PLANNING DIRECTOR'S SPECIAL PERMIT
1231 "I" STREET, SUITE 200, SACRAMENTO, CA 95814

- A. Negative Declaration
- B. Planning Director's Special Permit to allow a second 978 sq. ft. residential unit on an existing .23± acre deep lot in the Standard Single Family (R-1) zone.

LOCATION: 5886 28th Street

P90-332

EXHIBIT - A SITE PLAN

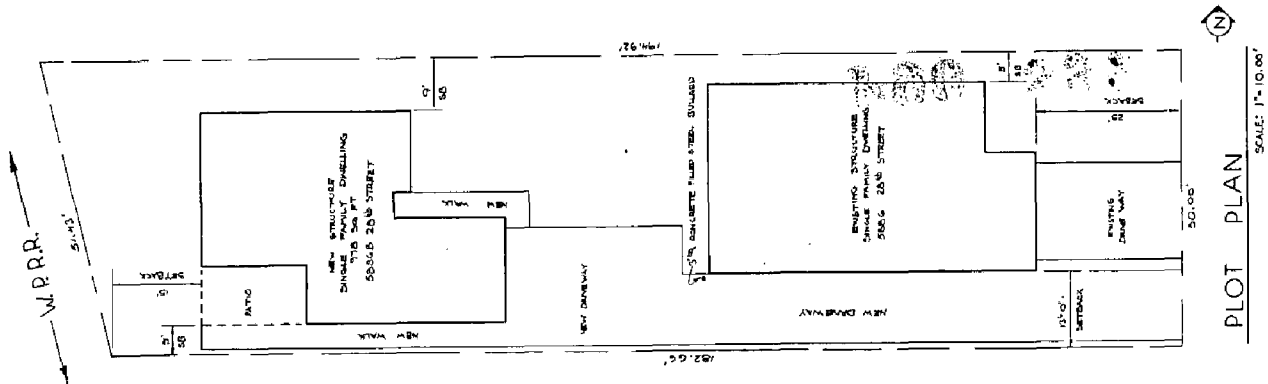
The plans as submitted indicate that more than the allowed 40% paving of the front yard setback area will occur if the proposed driveway is constructed. Staff has reviewed this problem with the applicant and the applicant has agreed to reduce the existing 20' x 25' driveway to a 10' x 25' driveway which will result in only 36% of the front yard area being paved. Staff recommends that the applicant submit a revised site plan reflecting the reduction of pavement in the front yard. As the proposed unit is compatible with the design of the existing unit and adequate yard area and parking are being provided for the unit, staff has no objections to the issuance of the special permit for the additional unit.
